Ref Document – EB0011 issue 01
Date July 19, 2006

PRODUCT INFORMATION BULLETIN

PJB NIPPER - STARTUP DELAY

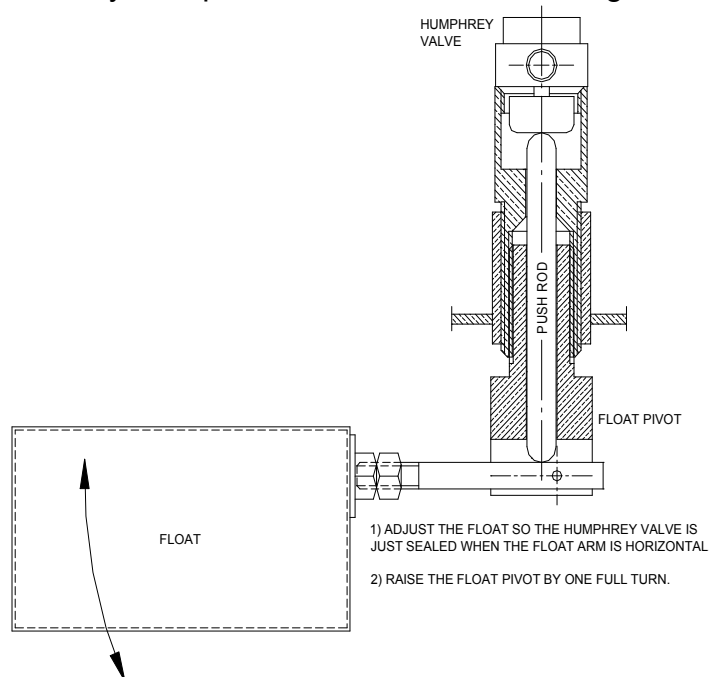
When attempting to restart the engine there can be a significant delay while the exhaust conditioner safety chamber is refilled with water. During that time the water lift pump is consuming air and consequently reducing the air pressure in the main air receivers. On occasions the system pressure is reduced to the point where the remaining pressure is insufficient to start the machine.

- 1) Set the safety float position as shown on the diagram below.

- 2) Ensure the supply air pressure to the water lift pump is set to 275kPa.
